<b>Title of Change:</b>	To add 39 OPNs for Packing quantity increase from 450ea/box to 1350ea/box that included pin dimension and color change for TO247&TT3PN for Automotive products
<b>Effective date:</b>	08 Feb 2022
<b>Contact information:</b>	Contact your local onsemi Sales Office or <a href="mailto:Daisy.Zhi@onsemi.com">Daisy.Zhi@onsemi.com</a>
<b>Type of notification:</b>	This Product Bulletin is for notification purposes only. onsemi will proceed with implementation of this change upon publication of this Product Bulletin.
<b>Change Category:</b>	Test Change
<b>Change Sub-Category(s):</b>	Shipping/Packaging/Marking

**PCN#: PB23734ZA**  
**Issue Date: Feb 08, 2022**

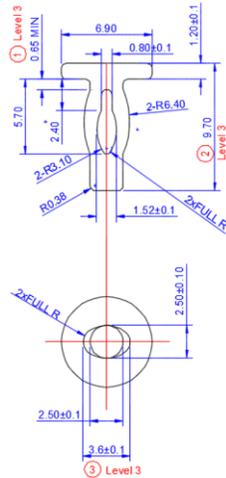
Current: MPQ&FBQ is 450EA;

Proposed: Changing MPQ&FBQ to 1350EA for uniformity.

TT3P/ TO247	Quantity per box	
	Current	Proposed
MPQ	450 units	1350 units(remove the bubble bag fill)
Entity Photos		
Stack Floors	5	15

**N57454G001**  
 Remark: tolerance: +/-0.15mm, color: white.

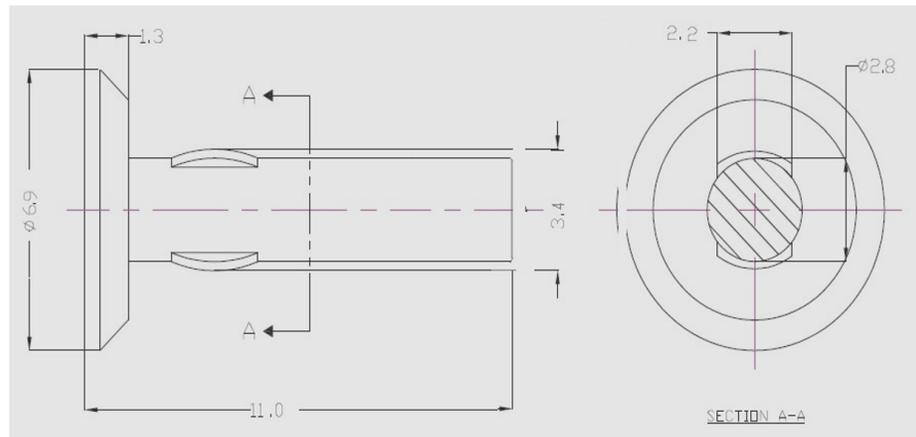
**Tube Pin Dimension & Color Change**  
**Currently:**

**Note:**  
 1. MATERIAL: NYLON  
 2. COLOR: GREEN/RED  
 3. STANDARD TOLERANCE = +/-0.20

**Proposed:**
